Origination Form
Proposed Revisions to a Standard Plans Index

Originator:	Gibbs, Shae	Index Number:	646-001
Date:	9/4/2025	Sheet Number(s):	1
E-mail:	shae.gibbs@dot.state.fl.us	Index Title:	Aluminum Post and Pedestal Mounted Pedestrian Detectors and Signals

ALUMINUM POST AND PEDESTAL MOUNTED
PEDESTRIAN DETECTORS AND SIGNALS

INDEX
646-001

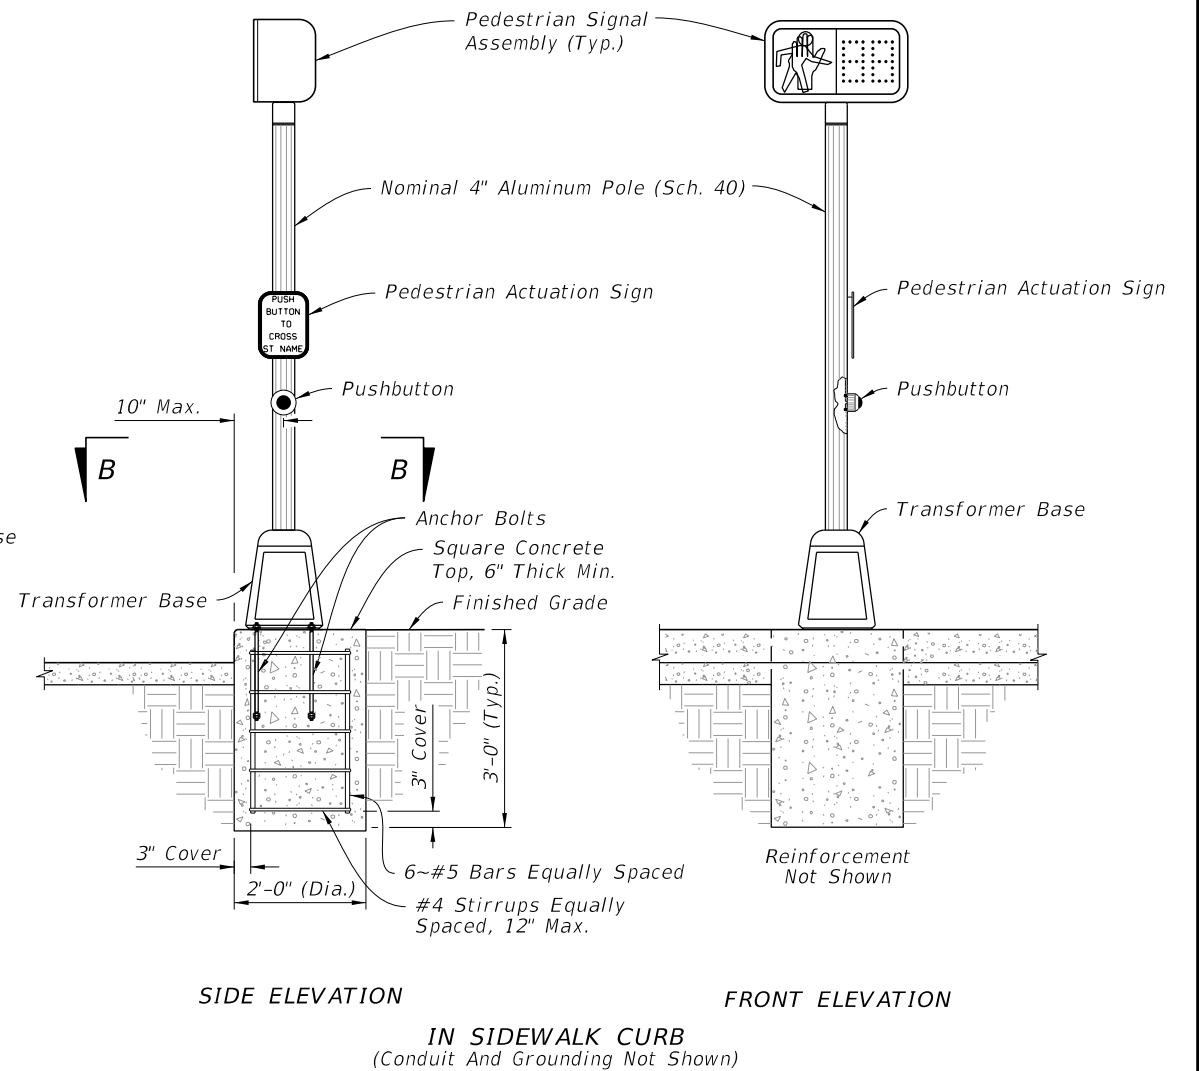
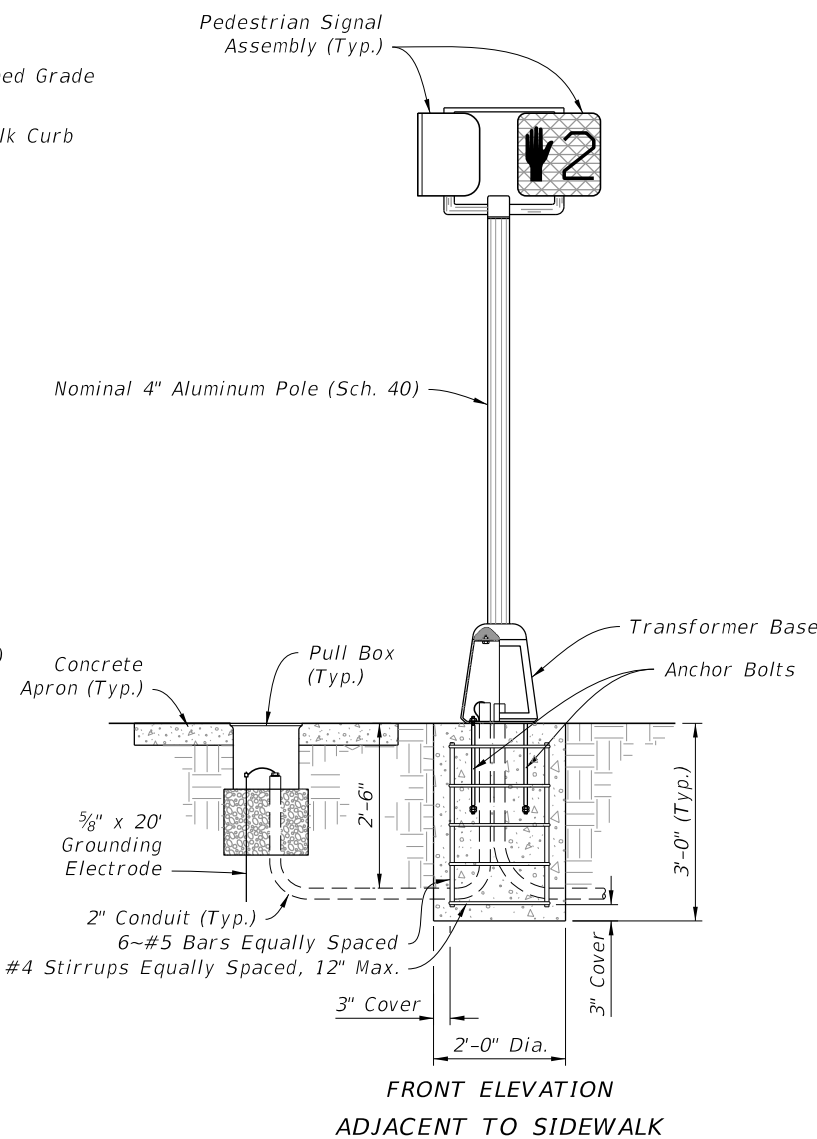
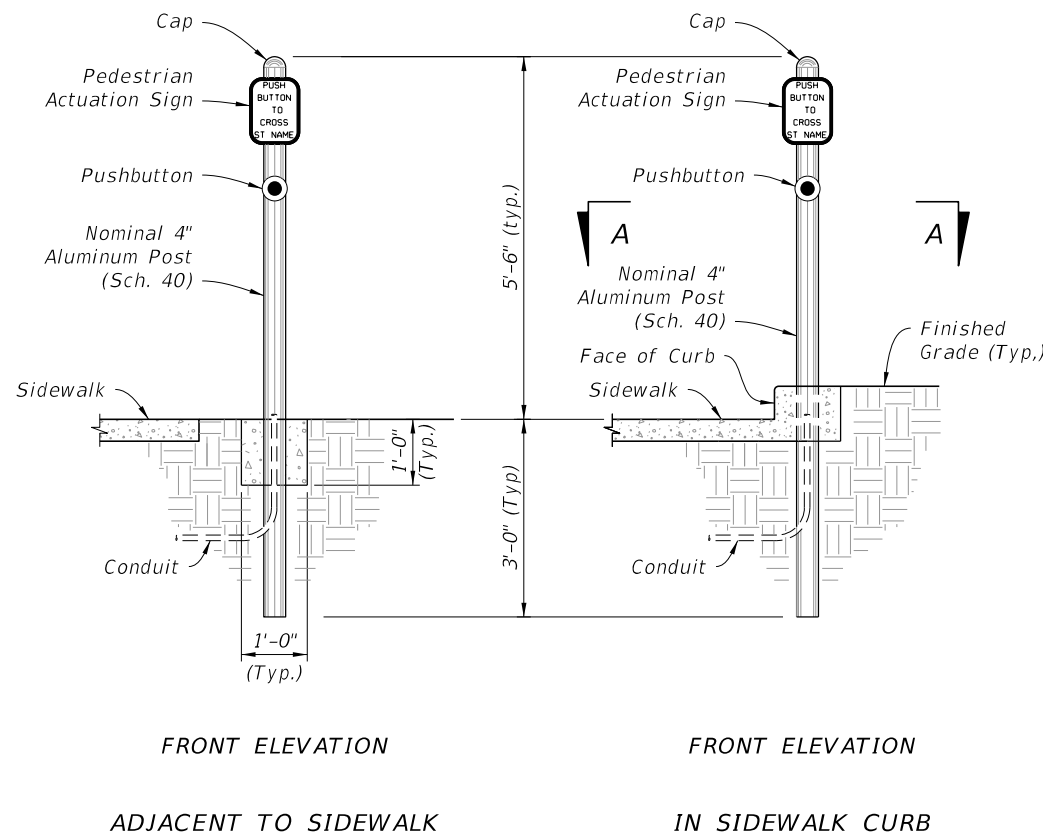
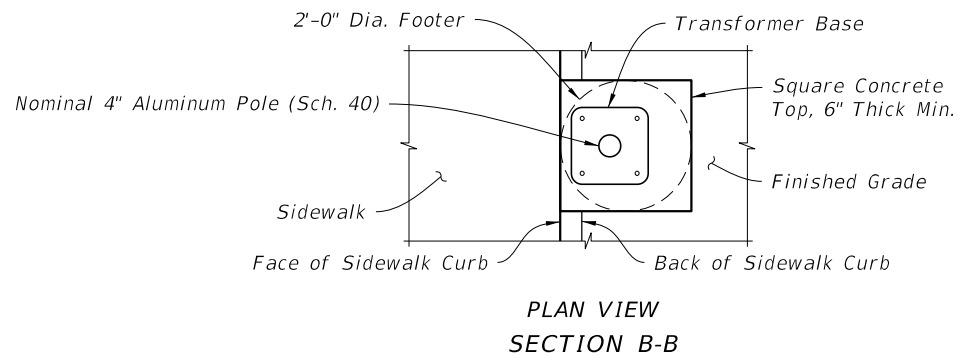
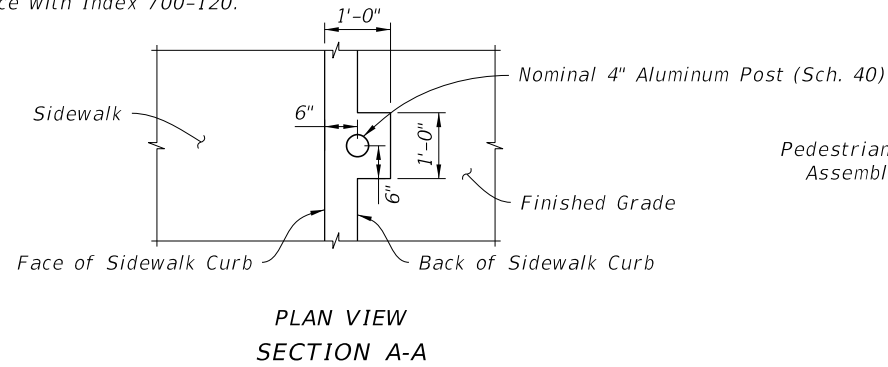
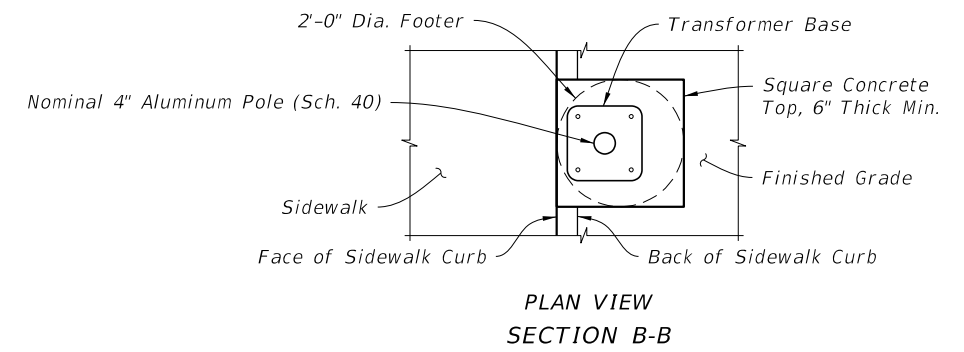
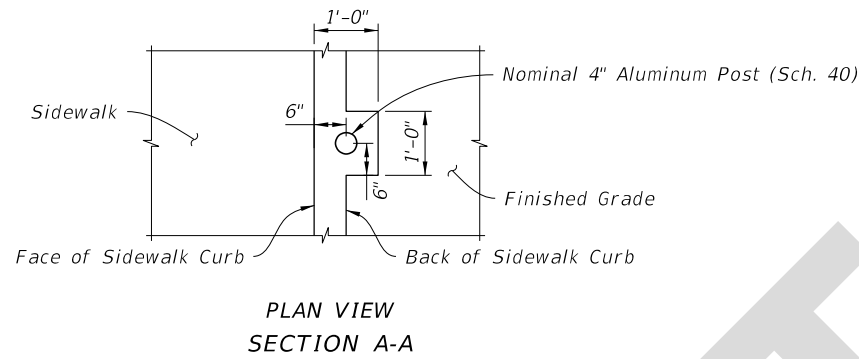
Sheet 1: Added Note 7 "For pedestal mounted signals, route and terminate the grounding electrode conductor to a ground lug within the transformer base."

This note was added to correspond with Standard Plans Index 653-001 in coordination with the TERL.

7. For pedestal mounted signals, route and terminate the grounding electrode conductor to a ground lug within the transformer base.
